Case No. 19-DDP-0019 Binding Elements

RESOLVED, the Louisville Metro Development Review Committee does hereby **APPROVE** the requested **Revised General District Development Plan** including release of binding elements associated with 15ZONE1028 for portion of lot 12 and adoption of binding elements associated with 9-67-05 as revised under docket 14489 to that portion; and **SUBJECT** to the following binding elements:

BLANKENBAKER STATION II
LOTS 11, 12, 14, 15A, 15B
SCHUTTE STATION PLACE & 2211 TUCKER STATION ROAD,
LOUISVILLE, KY 40299
TAX BLOCK 39, LOT 551 & LOT 68
DB 10713, PG 21; DB 9011, PG 656; DB 11531, PG 129

REVISED GENERAL & DETAILED DISTRICT DEVELOPMENT PLAN

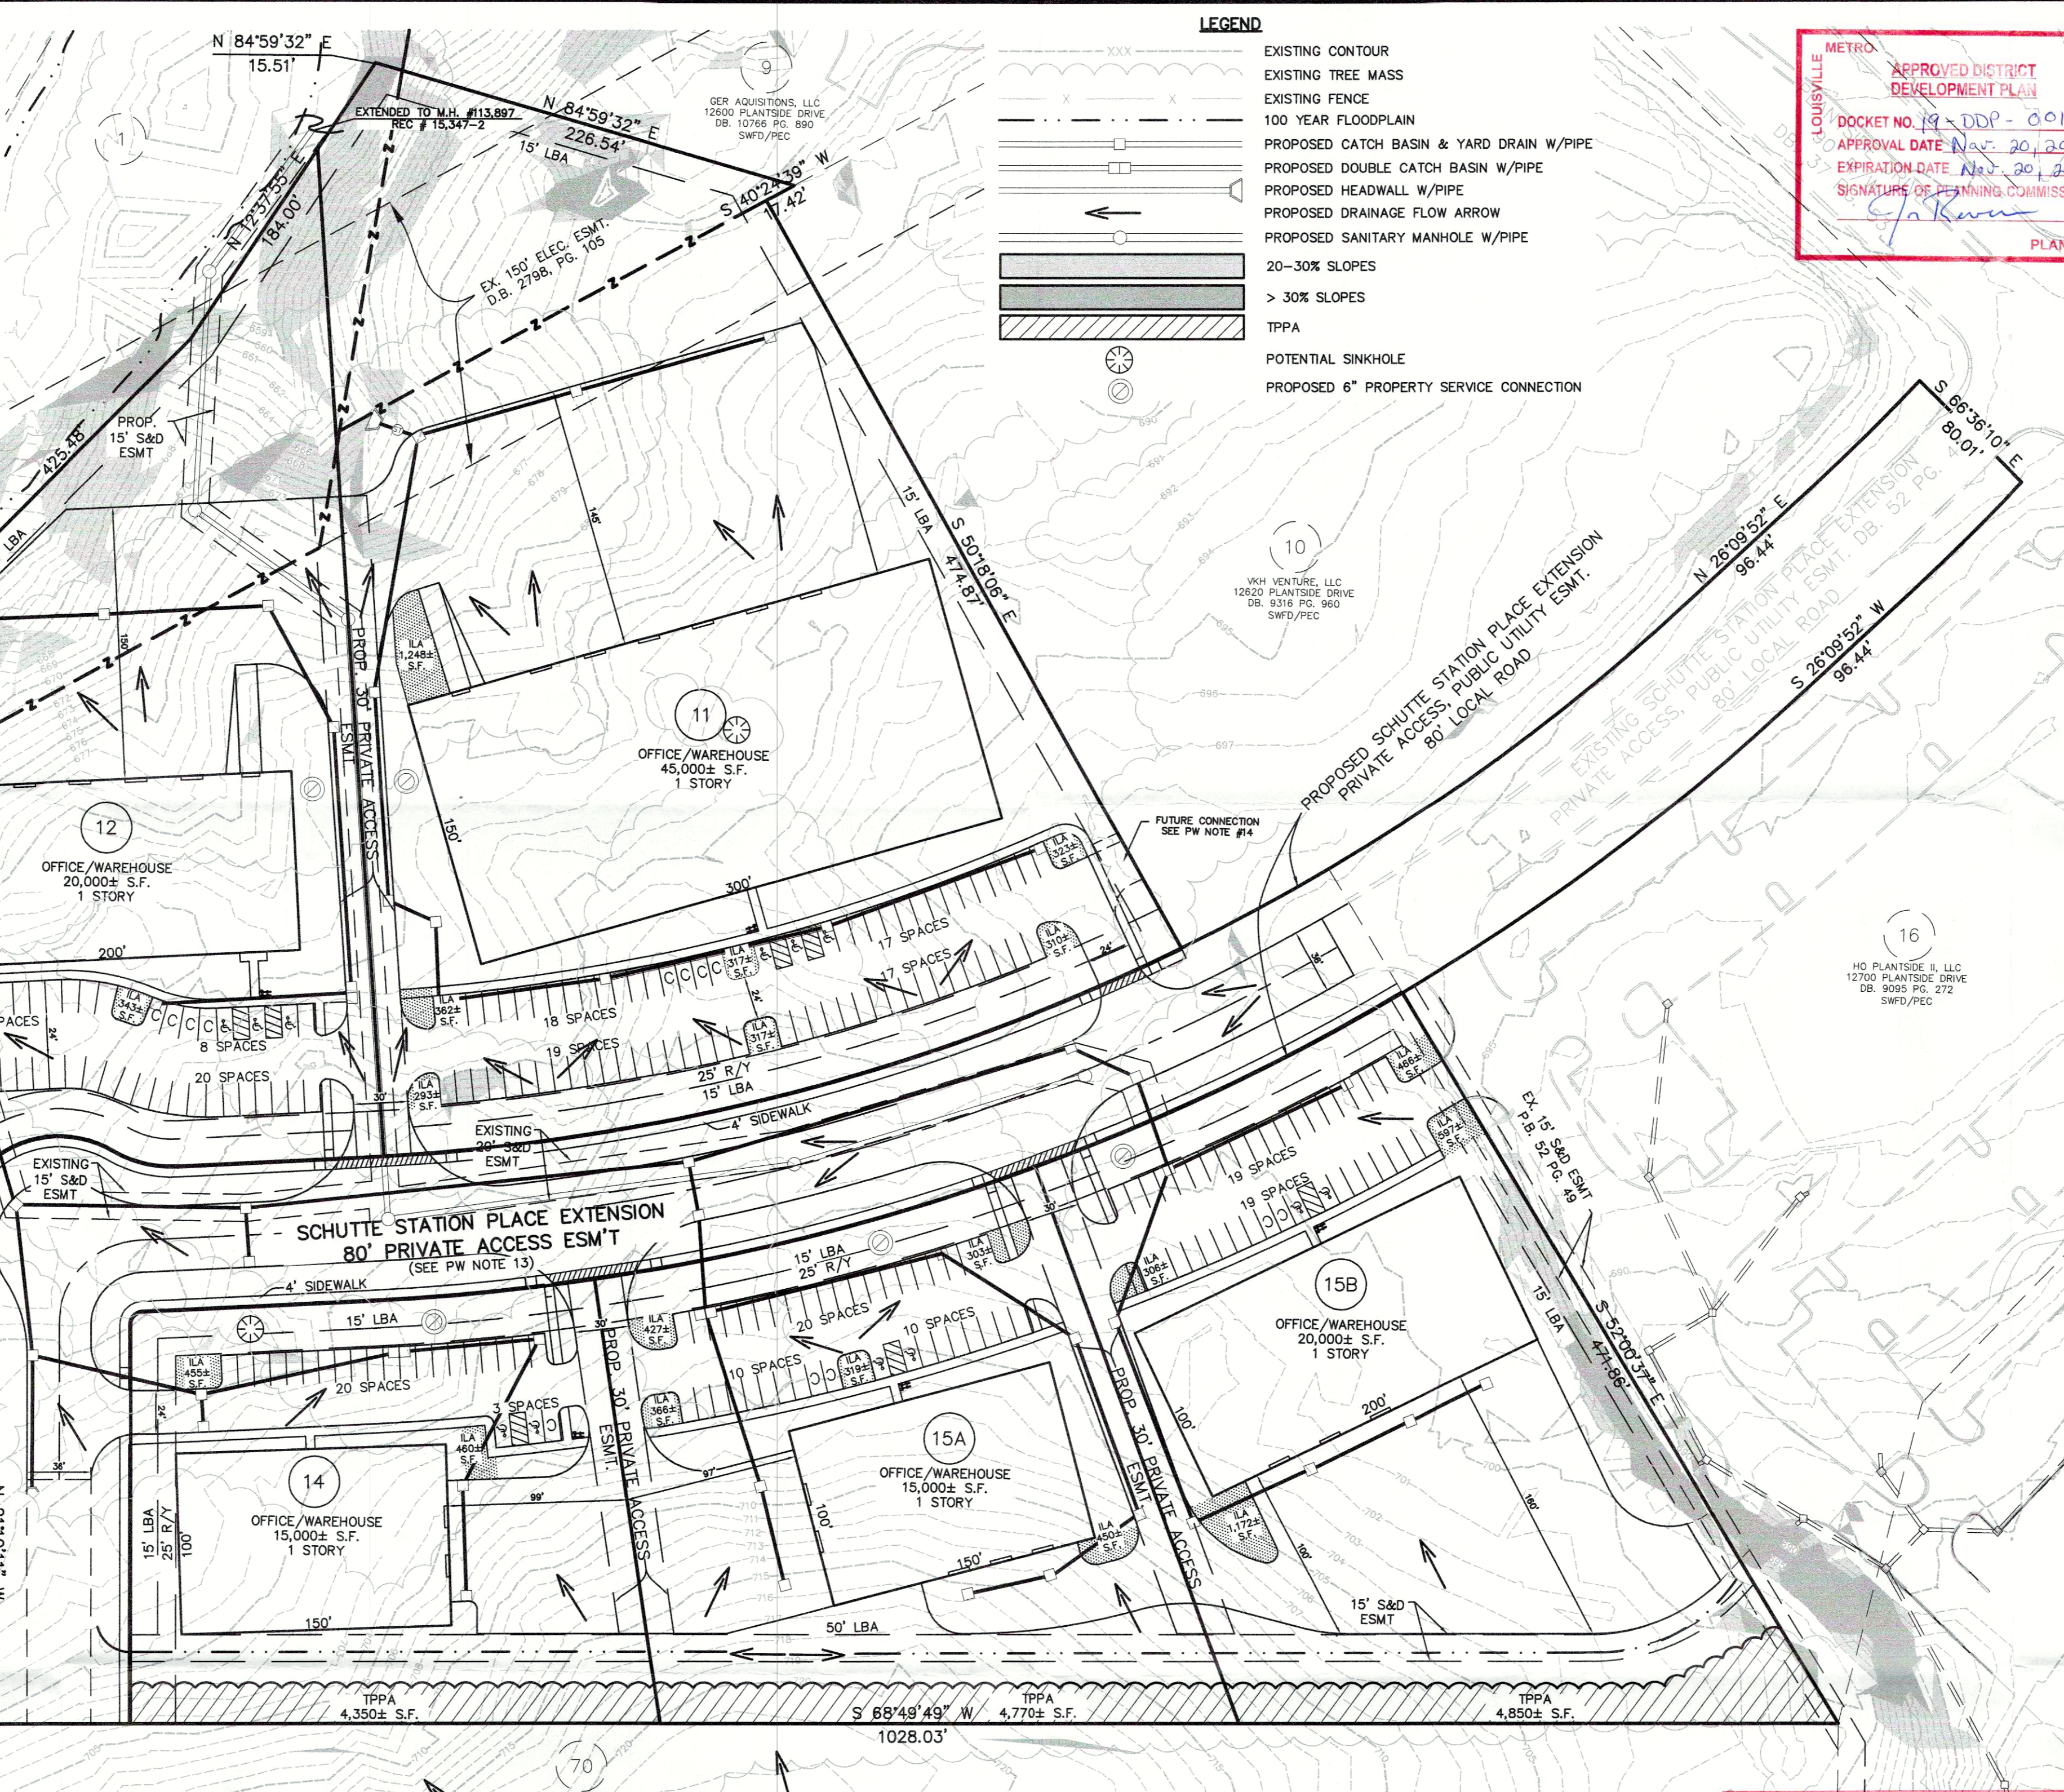
RESOLVED, the Louisville Metro Development Review Committee does hereby **APPROVE** the requested Revised Detailed District Development Plan with replacement of existing binding elements for a portion of lot 12, **ON CONDITION** that the second sentence is removed from the "Public Works" Note #14 on the proposed site plan that specified access to a future Lot #13, and **SUBJECT** to the following binding elements:
